Technical Bulletin

Model: P HP4-R2 Date			e: 19-Aug	-09	No.: RC264001	
Subject: Parts Information F				Prepared by: M. Kumagai		
From: 2nd Tech Support Sec. Service Support Dept.						
Classification:	Troubleshooting	Part info	ormat	tion 🗌 Actior		n required
	Mechanical	Electric	al		Servic	ce manual revision
	Paper path	Transmit/rec		eive	Retrofit information	
	Product Safety	Other ()	Tier 2

Model: P HP4-R2 D			Dat	te: 20-Aug-10		No.: RC264002
Subject: Parts information			Prepared by: M. Kumagai			
From: 1st Overseas Tech Support Sec., 1st PQM Dept.						
Classification:	Troubleshooting	Part info	ormat	tion	Action	n required
	Mechanical	Electrica	al		Servic	ce manual revision
	Paper path	Transmit/rec		eive	Retrofit information	
	Product Safety	Other ()	Tier 2

Model: P HP4-R2 Date			te: 24-Dec-10		No.: RC264003	
Subject: Parts information				Prepared by: M. Kumagai		
From: 1st Overseas Tech Support Sec., 1st PQM Dept.						
Classification:	Troubleshooting	Part info	orma	tion	Action	n required
	Mechanical	Electric	al	Service n		ce manual revision
	Paper path	Transmit/rec		/receive 🗌 Re		fit information
	Product Safety	Other ()	Tier 2

11.Plotter Unit 3 (C272/C273)

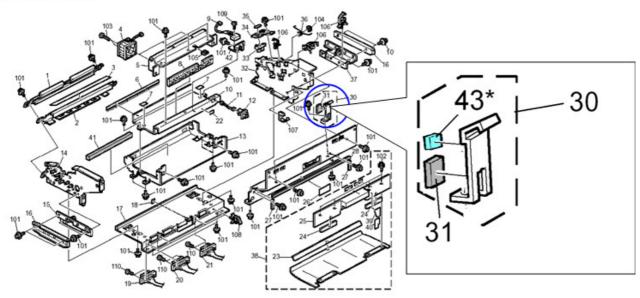
Change: Anti-vibration weights were added to the brake shoe.

Reason: To prevent a squeaking sound from being generated in the plotter unit.

- A: Master flange
- B: Anti-vibration weight (C2722230 / Index 43)
- C: Brake shoe

- Before you attach B to C, remove the grease on the surface of C.
 - Attach B to C with the following clearances:
 - Lengthwise: 0–1.5mm of the bend in C
 - Side to side: Line up the side edges of both B and C

24.Electrical Section 1 (C264)

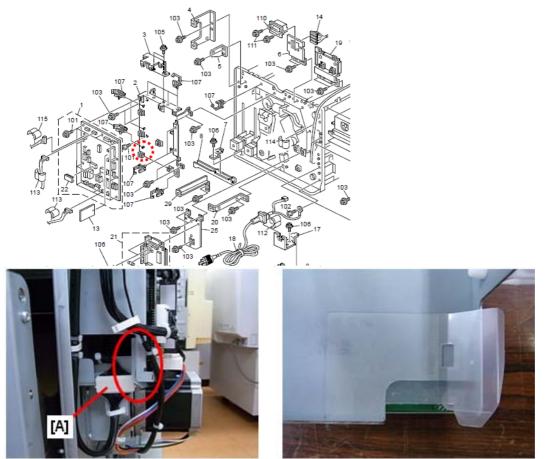
Change / **Reason:** A Guide Mylar was added to the back side of the MPU board bracket to prevent damage to the harness tube [A].

New part number	Description	Q'ty	Int	Page	Index	Note
C2725604	GUIDE:HARNESS	0-1		55	35*
